**Deviation request #100 for an ETSO approval for CS-ETSO applicable to Stand-alone Airborne Navigation Equipment using GPS Augmented by the Satellite Based Augmentation System (ETSO-C146a) & (ETSO-C146c)
Consultation Paper**

2. ETSO-C146#23 & ETSO-C146c#10 – Stand-alone Airborne Navigation Equipment using GPS Augmented by the Satellite Based Augmentation System

The following diagram depicts the FSD for a typical approach as it is specified in 2.2.4.4.2.2 and 2.2.4.4.2.3 and as calculated by the applicants navigators:

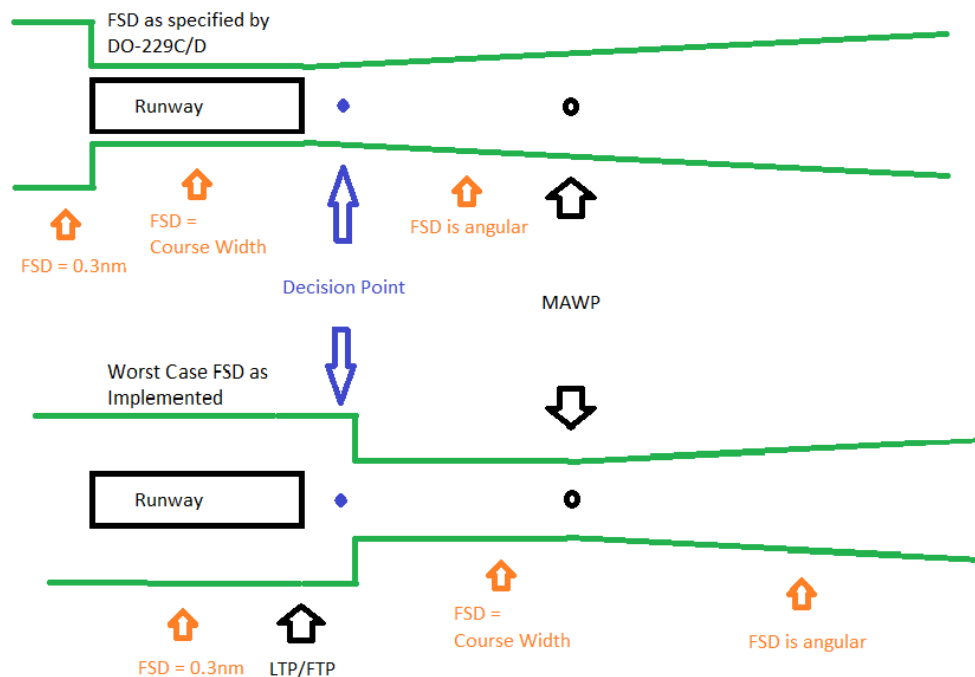
For all calculations of lateral FSD scale and lateral scale transition points that are based on the distance from the aircraft to the GARP in the above requirements, the applicant replaces that distance with the difference of the distance from the aircraft to the GARP and the distance from the LTP/FTP to the MAWP. Consequently, the FSD is affected as follows only for approaches when the LTP/FTP and MAWP are not co-located:

- From the FAWP (Final Approach Waypoint) to the MAWP, the FSD is angular but more restrictive than required by Section 2.2.4.4.2.2b and 2.2.4.4.2.3a.
- After the MAWP, the FSD is set to $\pm(\text{Course Width})$
- FSD will change to ± 0.3 nm before the departure end of the runway
- FSD could in some limited cases switch to ± 0.3 nm before the decision altitude when the distance between the LTP/FTP and MAWP is large.

We have reviewed the deviation again in light of issues regarding autopilot use below the DA(H) for LPVs and MDA for LPs and we do not see this as an issue that affects the deviation request.

If this deviation is used, the DDP has to state that the full scale deflections are not fully ILS look alike beyond the decision altitude/height. The reason for the inclusion in the DDP is that depending upon the system being ILS look alike or not, the performance demonstration of the autopilot has to be re-demonstrated or not. Without the information in the DDP, the installer will consider it is ILS look alike.

EASA accepts the deviation request.

Figure III-3-5-5. Typical SBAS APV I OAS contours for standard size aircraft

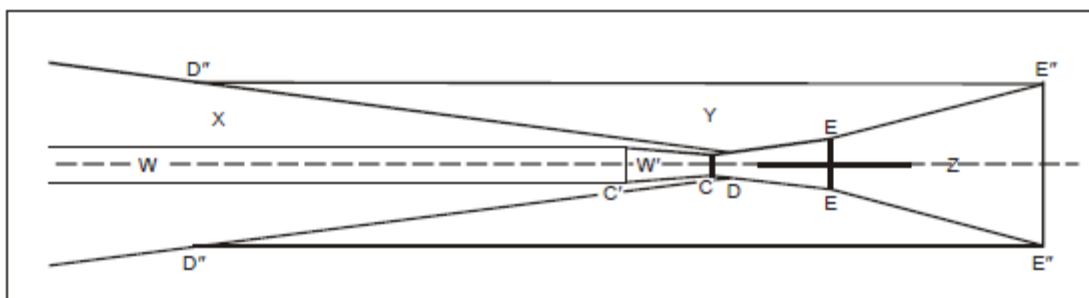
With the ICAO SBAS APV I/II criteria, the W, X, and Y surfaces in Figure III-3-5-5 (below) in ICAO Document 8168, Procedures for Air Navigation - Operations (PANS OPS) are based on the aircraft following the angular approach guidance to the Decision Altitude (DA).

After the DA, the W and X surfaces continue to the ground. The Y surface connects to the missed approach Z surface at E". The principle of the SBAS surfaces are based on the principle for Instrument Landing System surfaces, where there is no credit for missed approach guidance in the splay of the surfaces. So in Figure III-3-5-5, no credit for navigation guidance is used within the trapezoids defined by the line at C out to E and thence from E out to E". With SBAS, the missed approach guidance is accounted for in how far the Z surface splays out to the maximum width at E", which is 0.95 NM. The missed approach surface after E" remains at 0.95 NM width until the end of the missed approach if straight out, or, until a turn is encountered.

FIGURE 2-15 VTF FINAL APPROACH SEGMENT LATERAL DEVIATIONS WITH FAS DATA BLOCK

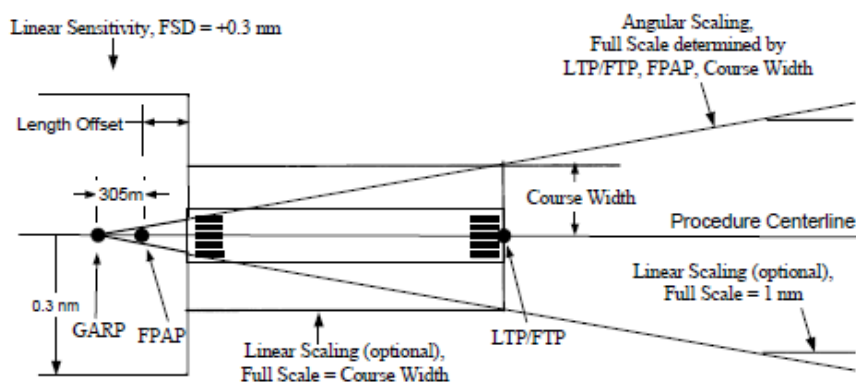
There are no reduced Obstacle Assessment areas in the vicinity of the runway that PANS OPS or TERPS takes credit for based on the RTCA DO-229 equipment scaling requirements depicted in DO-229 Figure 2-15; i.e., optional linear full-scale deflection (FSD) at course width.

The RTCA/DO-229 requirement for optional linear +/- 350 ft (107m) or angular lateral deviation scaling between the LTP/FTP and runway departure end does not impact the PANS-OPS Obstacle Assessment Surfaces over the runway. The PANS-OPS surfaces, provide adequate protection relative to the 0.3 NM lateral deviation scaling and alerting in the deviation request except for those few cases where the 0.3 NM lateral deviation scaling occurs prior to the approach procedure decision altitude (DA).
